March 25, 2008

DOMINION NUCLEAR CONNECTICUT, INC.
MILLSTONE POWER STATION UNITS 2 AND 3
APPLICATION FOR TECHNICAL SPECIFICATION IMPROVEMENT TO
ADOPT TSTF-490, REVISION 0, "DELETION OF E BAR DEFINITION AND
REVISION TO RCS SPECIFIC ACTIVITY TECH SPEC"

MARKED-UP TECHNICAL SPECIFICATION PAGES

DOMINION NUCLEAR CONNECTICUT, INC.
MILLSTONE POWER STATION UNIT 2

FIGURE 3.4.1

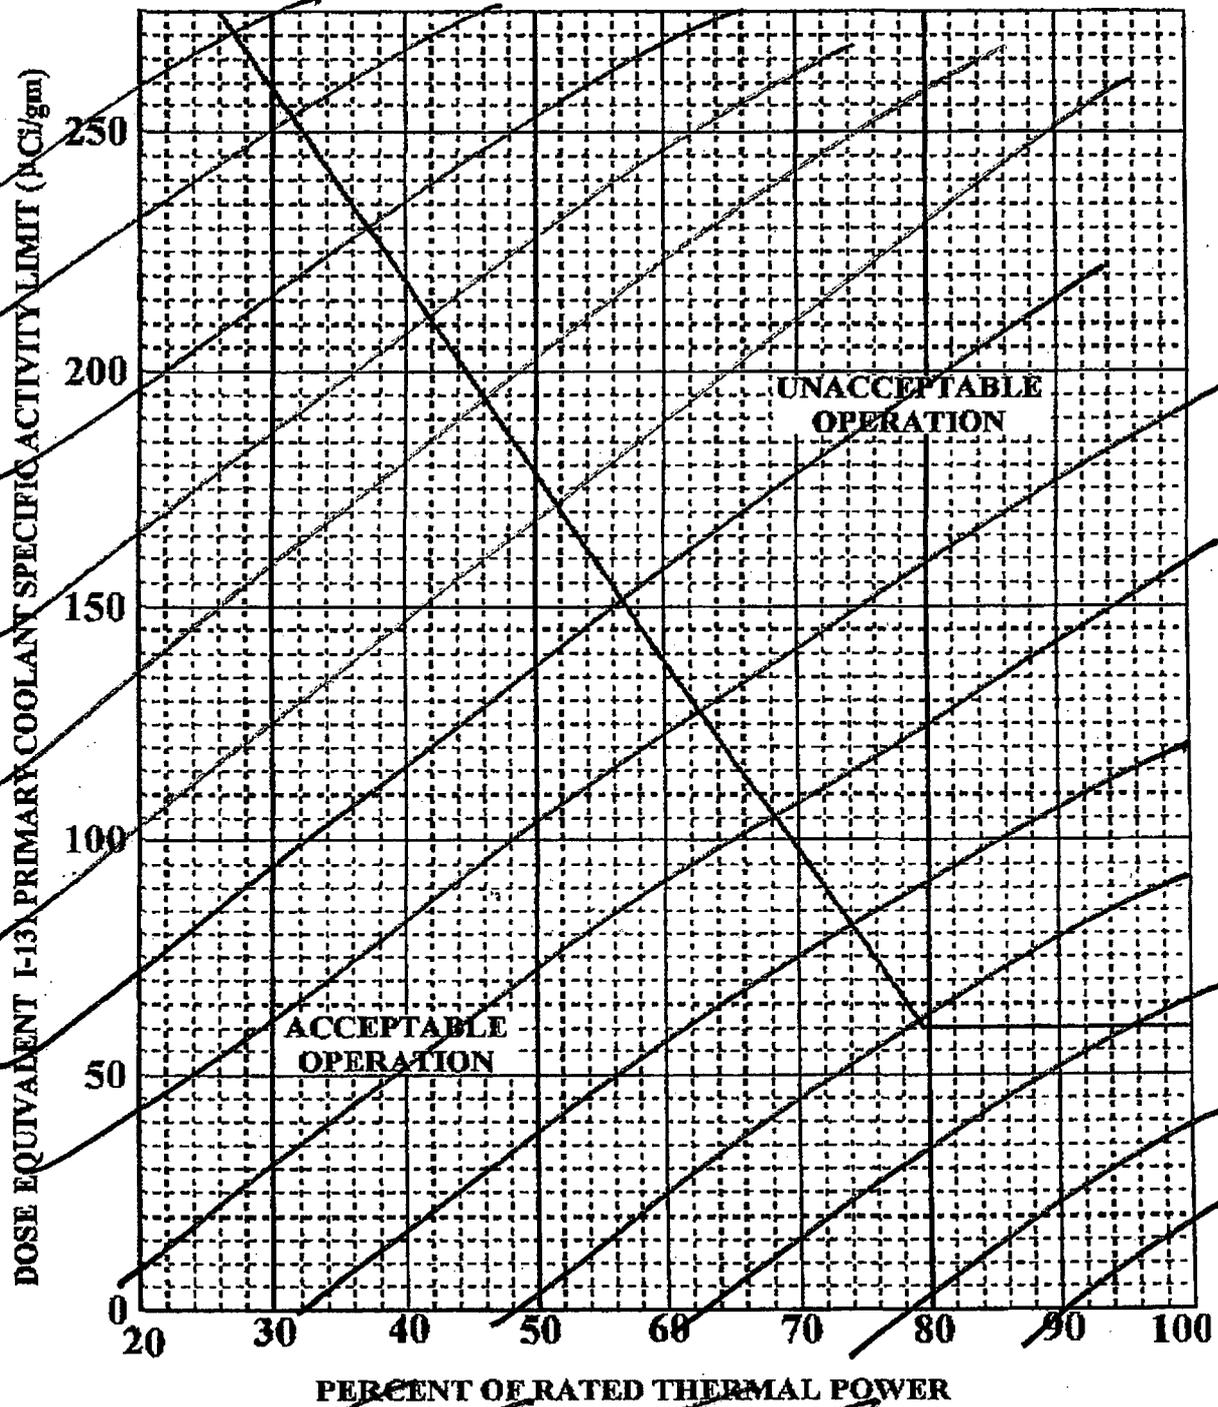
- Delete Figure 3.4-1, "DOSE EQUIVALENT I-131 Primary Coolant Specific Activity Limit Versus Percent of RATED THERMAL POWER with the Primary Coolant Specific Activity > 1.0 $\mu\text{Ci}/\text{gram}$ DOSE EQUIVALENT I-131," and Table 4.4-2, "PRIMARY COOLANT SPECIFIC ACTIVITY SAMPLE AND ANALYSIS PROGRAM."

- B. Modify ACTION (b), formerly ACTION (a), to delete the reference to Figure 3.4-1, and define an upper limit for DOSE EQUIVALENT I-131 that is applicable at all power levels.

- C. Modify ACTION (c), formerly ACTION (b), to delete the reference to Figure 3.4-1, and revise the required actions (Mode 3 within 6 hours, and Mode 5 within 36 hours) to agree with TSTF-490.

DELETE THIS MATERIAL.

FIGURE 3.4-1

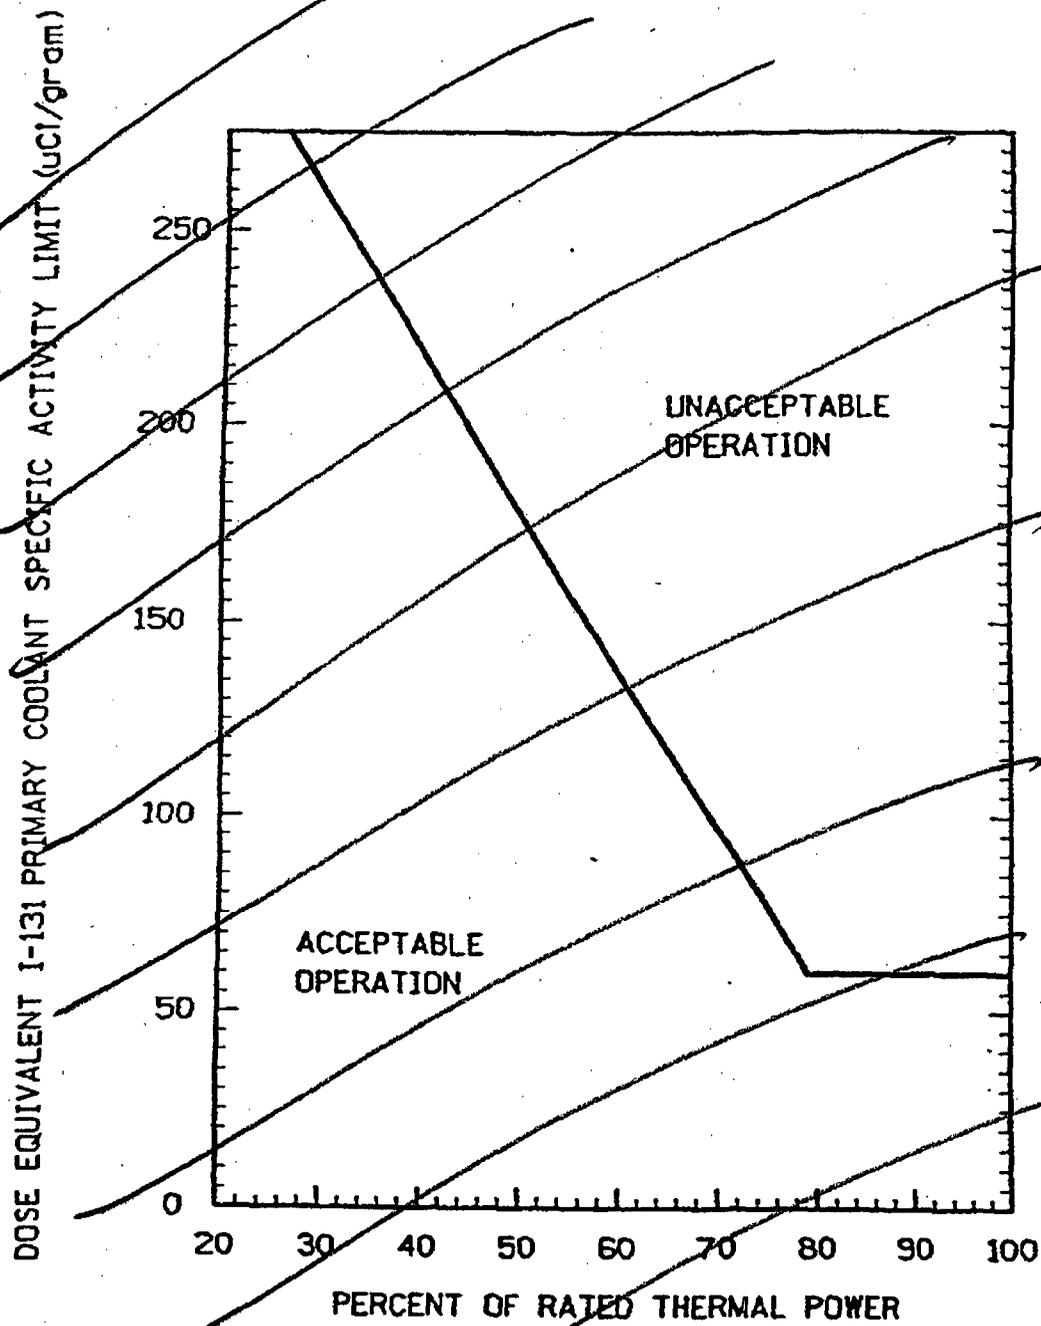
- Delete Figure 3.4-1, "DOSE EQUIVALENT I-131 REACTOR COOLANT SPECIFIC ACTIVITY LIMIT VERSUS PERCENT OF RATED THERMAL POWER WITH THE REACTOR COOLANT SPECIFIC ACTIVITY >1 $\mu\text{Ci}/\text{gram}$ DOSE EQUIVALENT I-131," and Table 4.4-4, "REACTOR COOLANT SPECIFIC ACTIVITY SAMPLE AND ANALYSIS PROGRAM."

DELETE THIS PAGE.
